From: Eccleston, Charles
Sent: Monday, August 09, 2010 11:04 AM
To: Rikhoff, Jeffrey
Subject: Chapter 2, 4, & 8
Attachments: ✓ 4.9.7 Environmental Justice (062910).docx; 4.1 Land Use (050610).docx; 4.9, 4.9.1 (050610).docx; 4.9.2 Housing (051910).docx; 4.9.3 Public Utilities (051910).docx; 4.9.4 Offsite Land Use (051910).docx; 4.9.5 Transportation (051910).docx; Chapter 2 -V.2[1] (GB, DB).docm; Chapter 8 v 2 (4) (most recent), AT, DB).docx

Here is chapter 2, 4, and 8. If you can simply add any changes to these files, I can send then send the files back to AECOM. They will do a "compare" between your version and their baseline version, and incorporate your changes into the baseline version.

4.9.7 Environmental Justice

Figure 2-5. Location of Salem and HCGS Site, within a 50-Mile Radius
(Source: PSEG 2009a, PSEG 2009b)

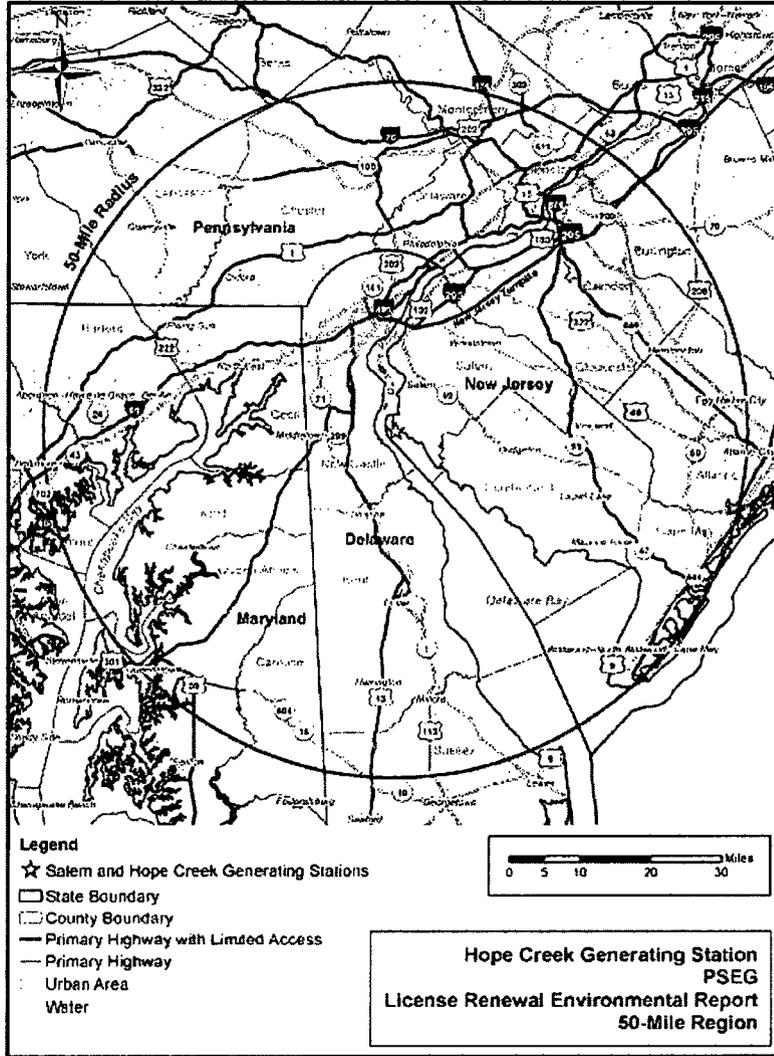
Comment [C1]: We should use an NRC source for this information.

Figure 2-7. Simplified Design of a Boiling Water Reactor (NRC 2010b)

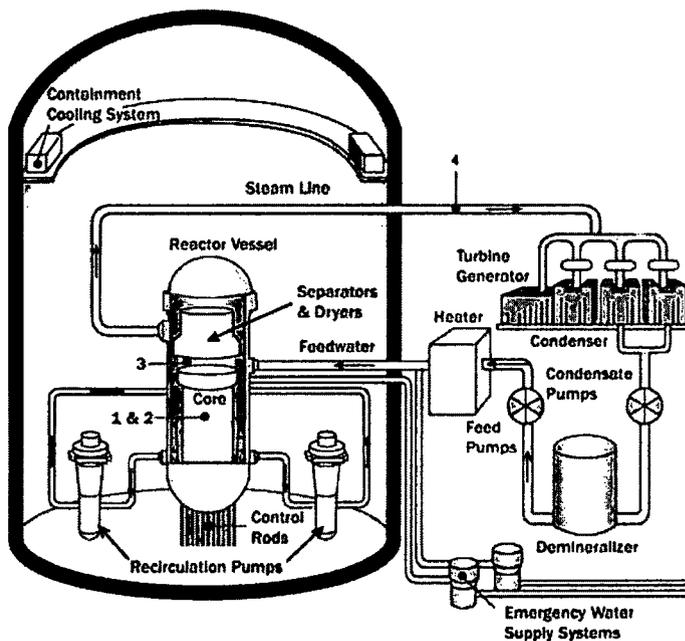
Comment [C3]: See above comment (S1) to use an NRC reference, NUREG-1350
